**Comments on
PGE 2009 Integrated Resource Plan
Public Utility Commission of Oregon
Docket No. LC 48**

May 19, 2010

Public Utility Commission of Oregon
Docket No. LC 48
Comments on PGE 2009 Integrated Resource Plan
PUBLIC
Protected Materials Redacted

Figure 12A-2: Combined Probability of Good and Bad Outcomes for Boardman Portfolios

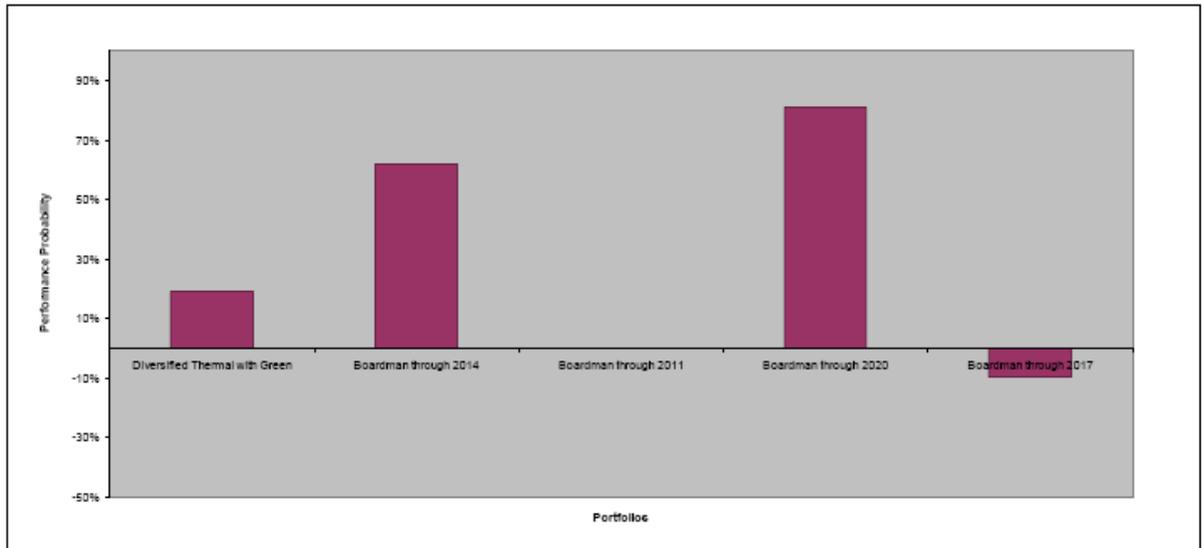
In the IRP Addendum, PGE presented Figure 12A-2 with the Combined Probabilities of Good and Bad Outcomes for Boardman Portfolios. This Figure is reproduced below. It shows that the Boardman through 2014 and the Boardman through 2020 portfolios both have significantly higher probabilities of achieving good outcomes and avoiding bad outcomes than the Diversified Thermal with Green portfolio. Unfortunately, the Boardman through 2017 portfolio included in this Figure is the completely unrealistic scenario in which the plant is assumed to be retired immediately after the investments are made in a new scrubber and other emissions controls.

PGE states that “Better portfolios have a high probability of *combined* good vs. bad outcomes.”⁶² Under that criterion, the Boardman through 2014 portfolio certainly is a “better” portfolio than the Diversified Thermal with Green portfolio.

Figure 16: Boardman Capacity Factors 2010-2040 in Diversified Thermal with Green Portfolio

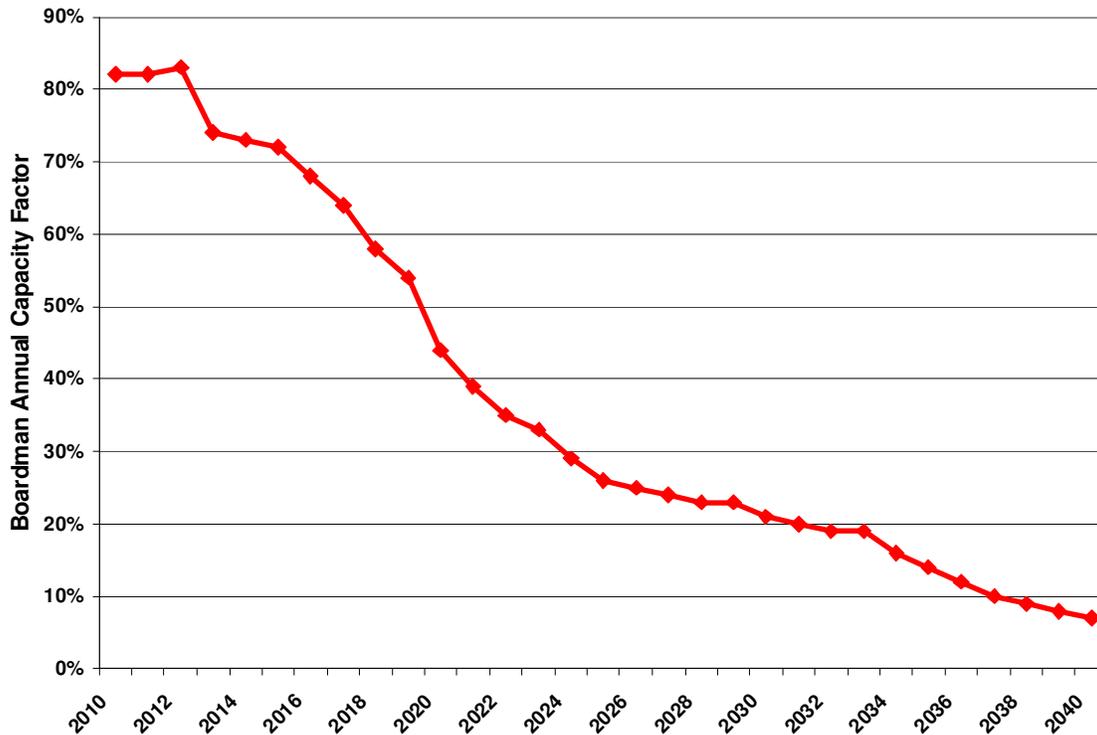
Figure 16, below, presents the annual Boardman plant capacity factors calculated by the Aurora model for PGE’s preferred Diversified Thermal with Green portfolio. As can be seen, by 2020 the Boardman plant would have a capacity factor of only 44 percent which is more indicative of an intermediate unit than a baseload plant and suggests perhaps seasonal dispatch and operation during peak load hours. By 2030, the unit would have a capacity factor of only 20 percent, which suggests less seasonal dispatch and increased dispatch as a peaking unit.

This steady decline in performance raises serious questions about the prudence of investing \$510 million for environmental upgrades on a coal-fired unit that would no longer be operating at the 70 percent to 80 percent annual capacity factors typically achieved by baseload generating facilities.

Figure 17: NPVRR Differences between PGE Boardman through 2014 and Boardman through 2020 Portfolios (2009\$ Millions)

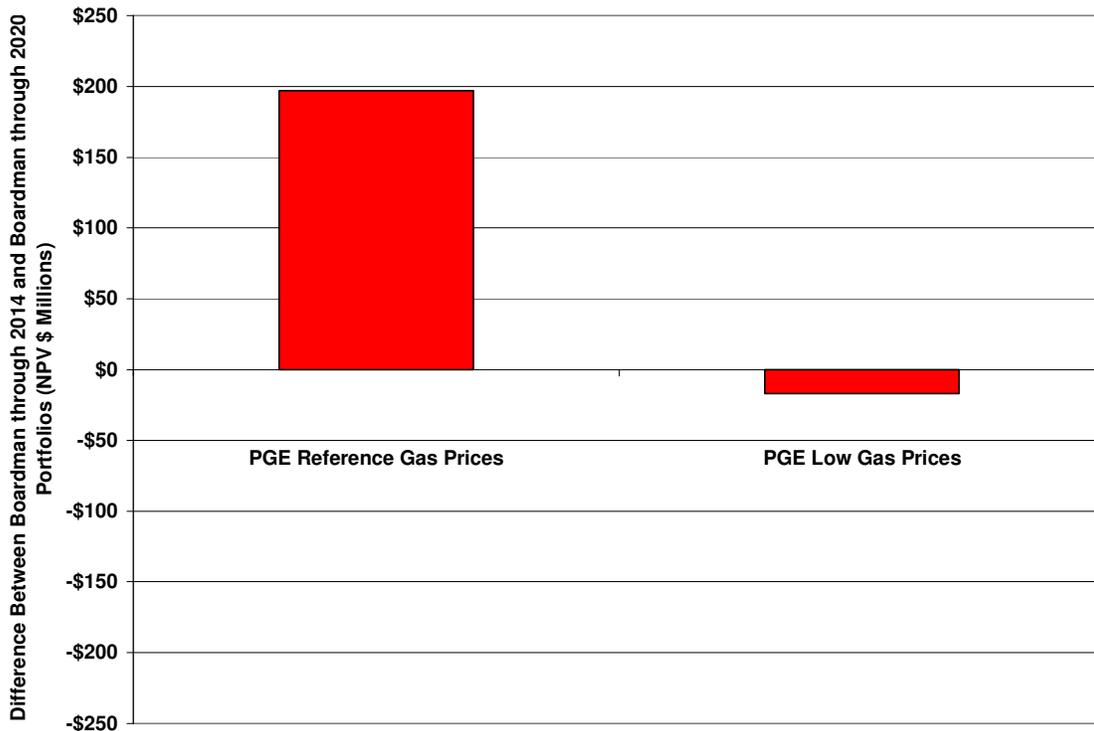
For example, as shown in Figure 17, below, the \$197 million (in 2009\$) NPVRR benefit shown for the Boardman through 2020 portfolio with PGE’s reference case gas prices becomes a \$17 million (in 2009\$) benefit for the Boardman through 2014 portfolio with PGE’s low gas prices.⁶⁵ As shown in Figure 1 and Figure 4, above, PGE’s low IRP gas price forecast is only moderately lower than the reference case forecasts from NWPCC, the Oregon PUC staff, AEO 2010, and PIRA 2010.
